Louis + Debbie Hammer

HAMMER

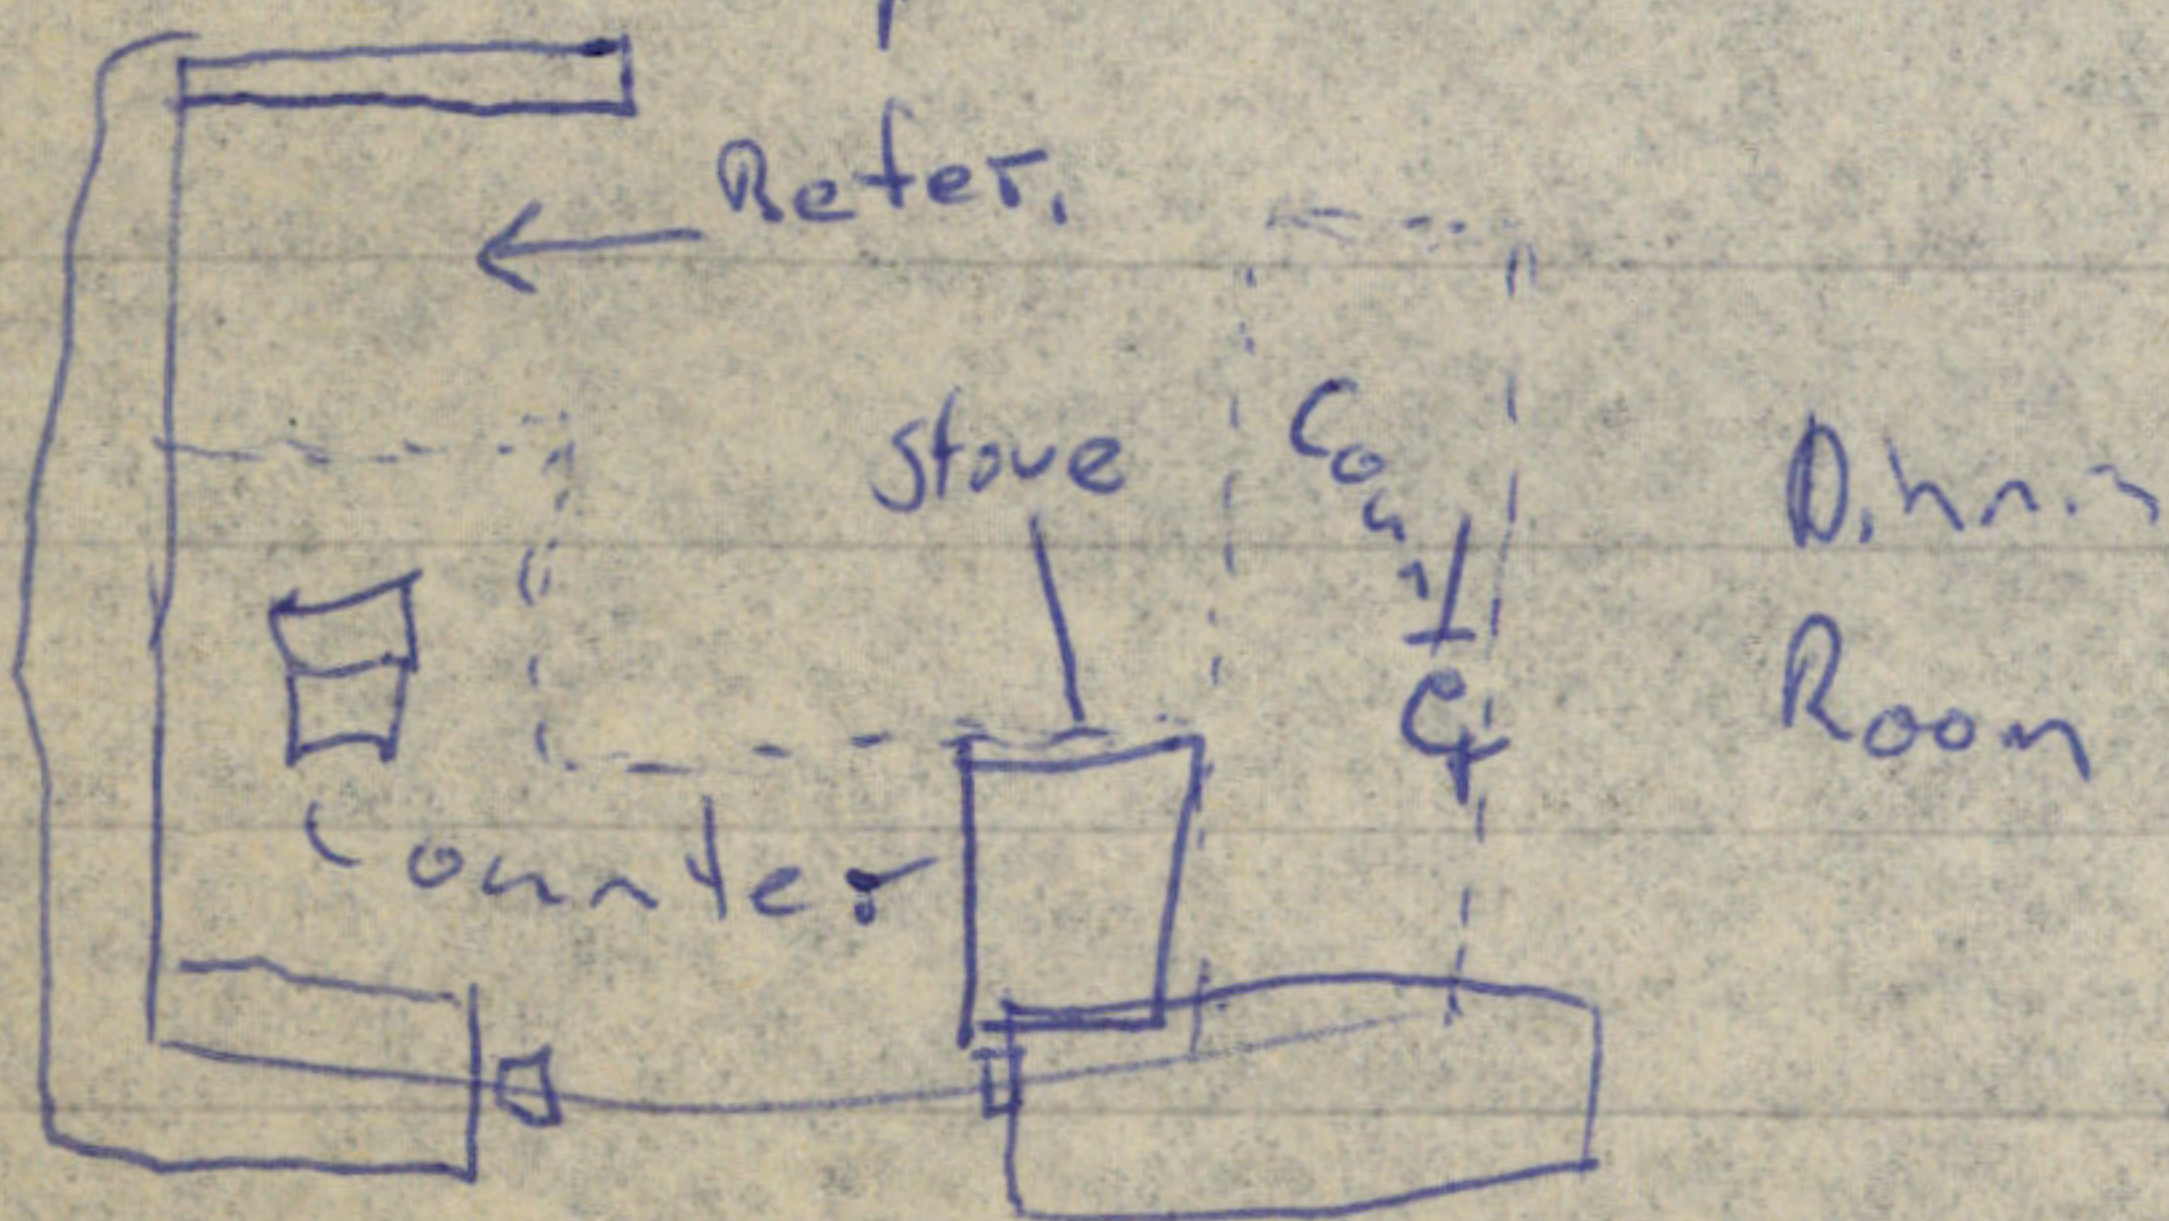
- 1) Bathroom width must be increased to 1.43 meters according to Gabi to pass building code.
- 2) Draw in on floor plan the master-bedroom windows plus increase the width of the wall to make it an external.
- 3) Remove the wall between stairs and living room to make it open to living room, possible alternative is a waist high siding to stairs.
- 4) Counter in kitchen should be between kitchen + Dining room rather than ~~Dining room~~, living room
- 5) Refrigerator should be moved to opposite corner of kitchen which needs a little larger wall extending from west wall of kitchen to hide it from living room at least 32 inches
- 6) Remove "T" shaped wall in center of kitchen, L.R., + D.R.

7) Double sink - milk - meat

8) No short wall extending out of south side of kitchen between kitchen + Dining Room. where Refrigerator once was.
